NWS: EHB-6, Maintenance Note 31

BARD AIR CONDITIONING UNIT CONDENSER MOTOR WIRING

DOPPLER METEOROLOGICAL RADAR WSR-88D

Issuance Number: EHB 6-03-00

Figure 1. Outside Component Layout

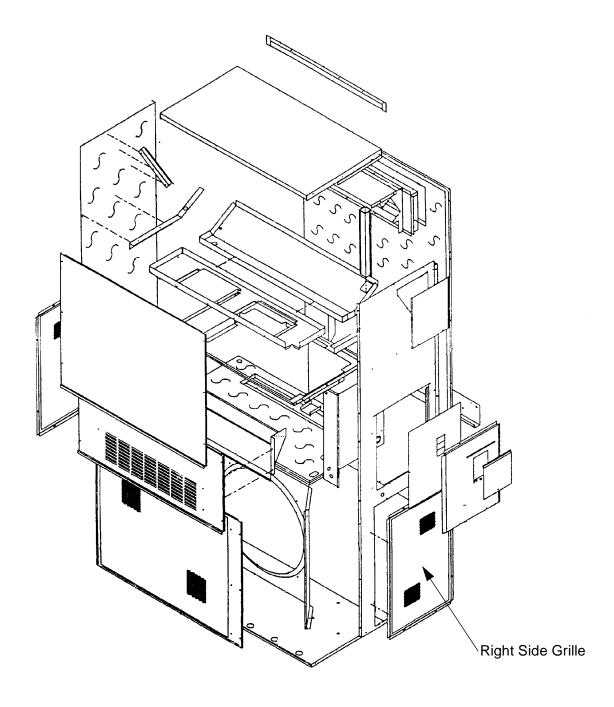
- b. Proceed to the outside of the RDA shelter to the Bard air conditioning units.
- 2. Perform the following steps to repair and reroute the wires:
 - a. Remove the lower right side grille by removing the (8) eight screws using a 5/16-inch nut driver. (See Figure 1).

Figure 2. Example of Bard Air Conditioning Unit Wire Repositioning

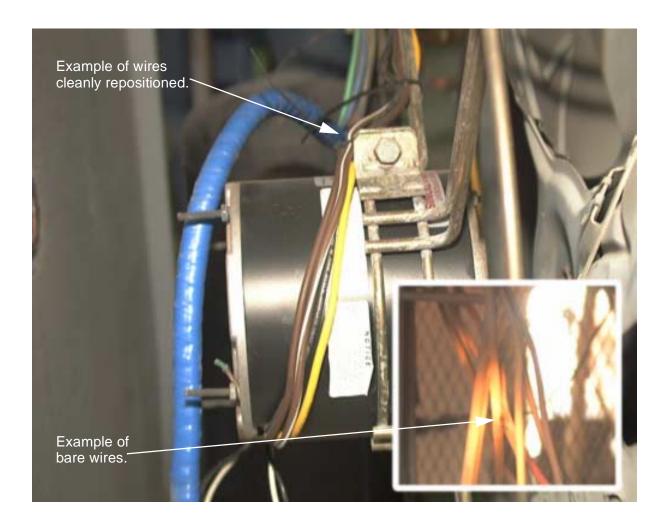
- d. Using electrical tape, secure the three loose wires together overlaping the previously taped areas by approximately 2 inches to each side.
 - e. Permanently secure any loose or dangling wires, using tie wraps, to a fixed position. (See Figure 2).
